**Marrickville Metro Shopping Centre Redevelopment
Concept Plan Application under Part 3A of the Environmental Planning and
Assessment Act 1979**

Introduction

**REQUEST FOR PROVISION OF KEY ISSUES AND ASSESSMENT REQUIREMENTS –
CONCEPT PLAN FOR PROPOSED RETAIL EXPANSION, MARRICKVILLE METRO 34
VICTORIA ROAD, 13-55 EDINBURGH ROAD AND PART OF SIDMORE STREET (MP
09_0191)**

**KEY ISSUES AND ASSESSMENT REQUIREMENTS – CONCEPT PLAN FOR PROPOSED
RETAIL EXPANSION, MARRICKVILLE METRO 34 VICTORIA ROAD, 13-55 EDINBURGH
ROAD AND PART OF SMIDMORE STREET (MP09_0191)**

Preferred option (Option 1)

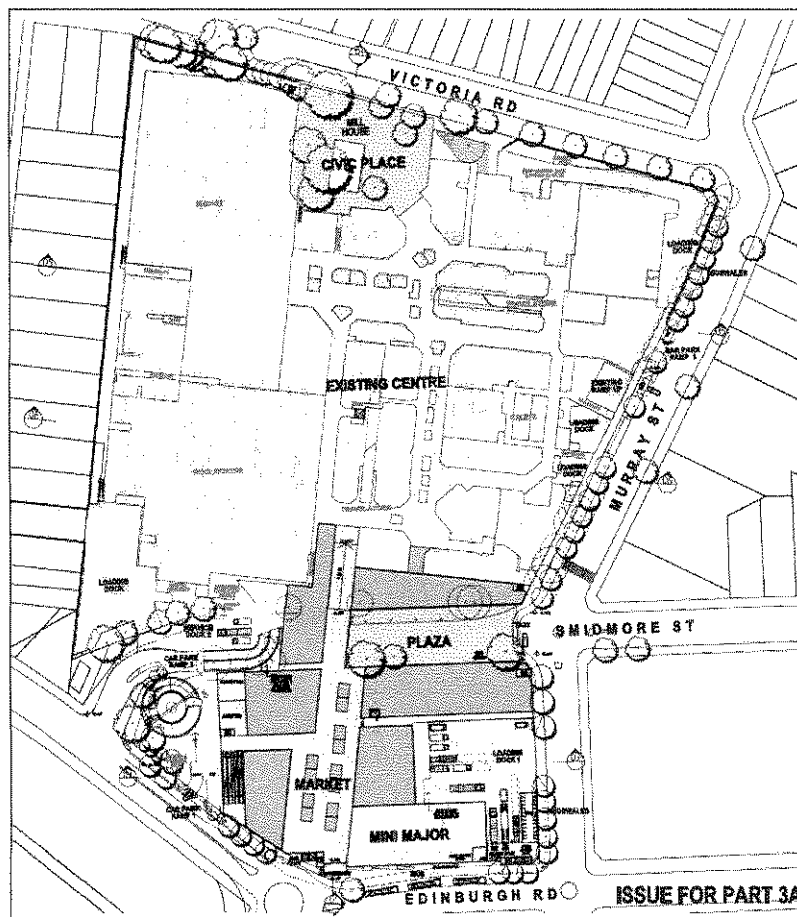
Council does not grant owner's consent with regard to the Option 1 development proposal which proposes the closure of part of Smidmore Street including the airspace, and advise the Department of Planning and AMPCI accordingly.

For Option 1, Council's consent (as the owner of Smidmore Street) is required. AMPCI has requested that Council grant owner's consent to its application. The DoP wrote to Council on 20 May 2010 seeking advice as to whether Council intended to grant owner's consent. A reply was provided to the DoP on 3 June 2010 advising:

Alternative option (Option 2)

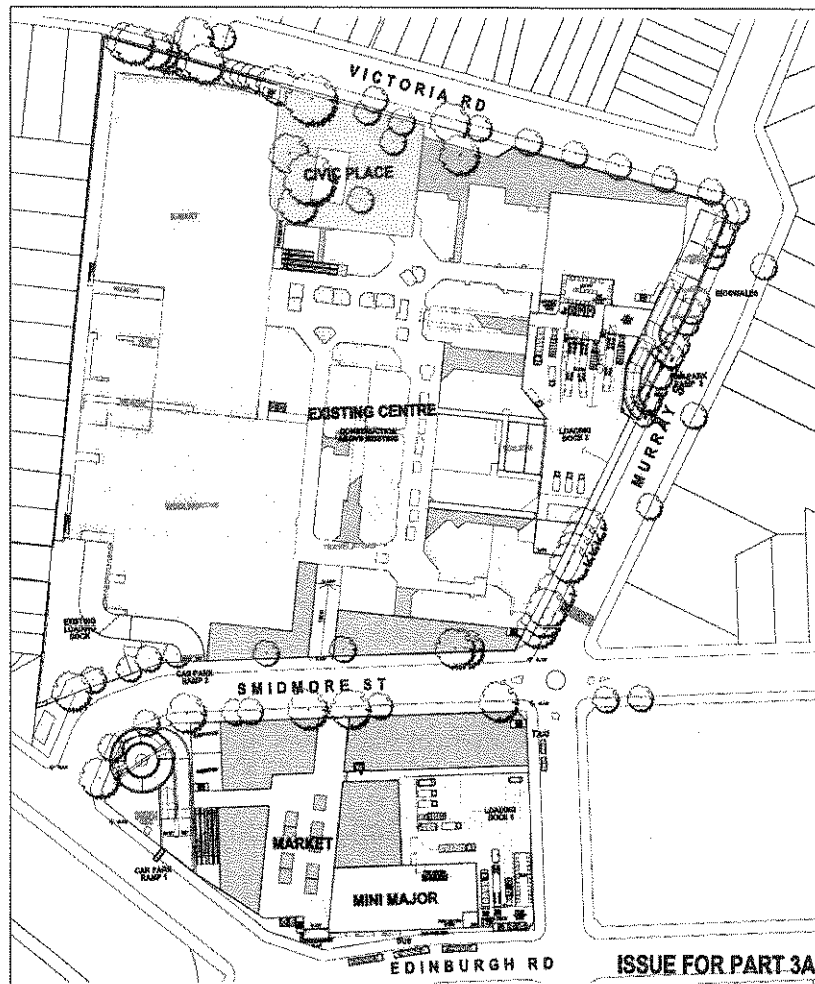
- The TMAP does not provide a proper assessment of the Option 2; where Smidmore Street will remain open for vehicular traffic.
- The TMAP underestimates the increase in traffic that will use Edgeware Road north of Llewellyn Street, as well as Alice Street and the section of Victoria Road east of the Metro.
- Based on above the traffic impacts at the Edgeware Road / Alice Street / Llewellyn Street and Edgeware Road / Victoria Road intersection would be worse than predicted in the TMAP.

PROPOSED PEDESTRIAN ROUTE IMPROVEMENTS

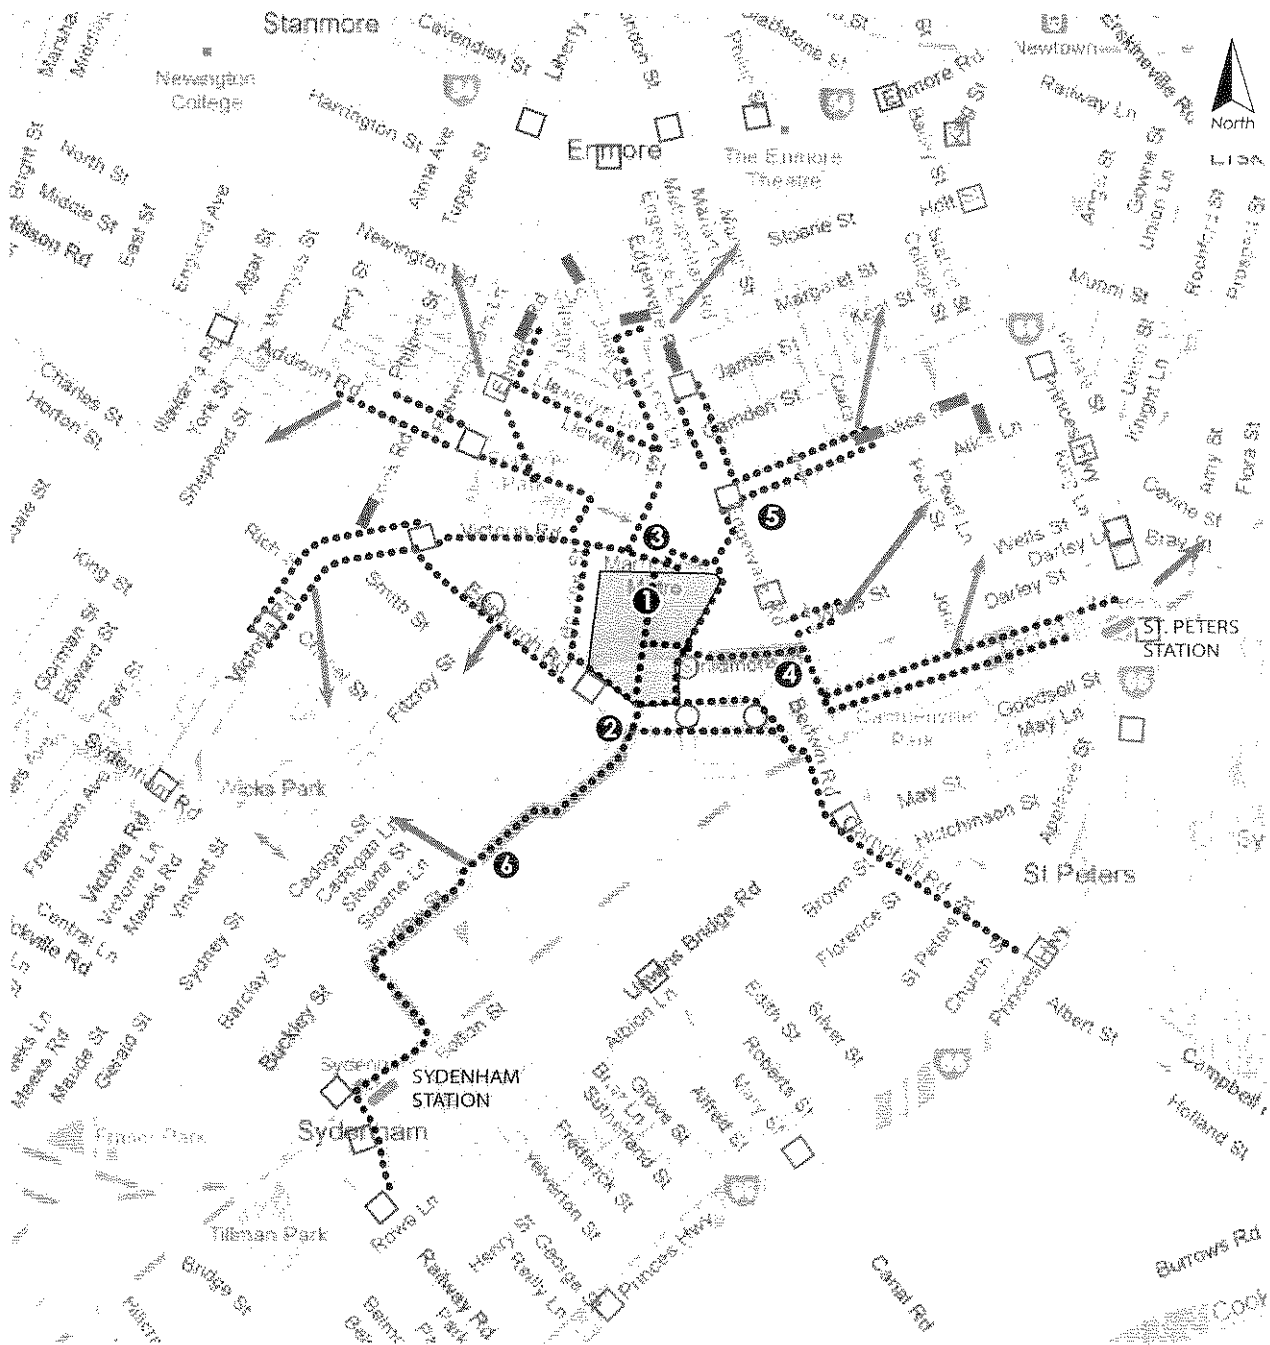
The proposed pedestrian improvements are shown in Figure 10 of the Halcrow report. One anomaly in Figure 10 is item 5, which is new traffic signals at the intersection of Edgeware Road and Victoria Road. This improvement is not listed anywhere else in the body of the report but is included in the list of Transport Improvements at the rear of the report. The matter requires clarification, to determine if the proposed traffic signals are part of the proposed pedestrian improvements.
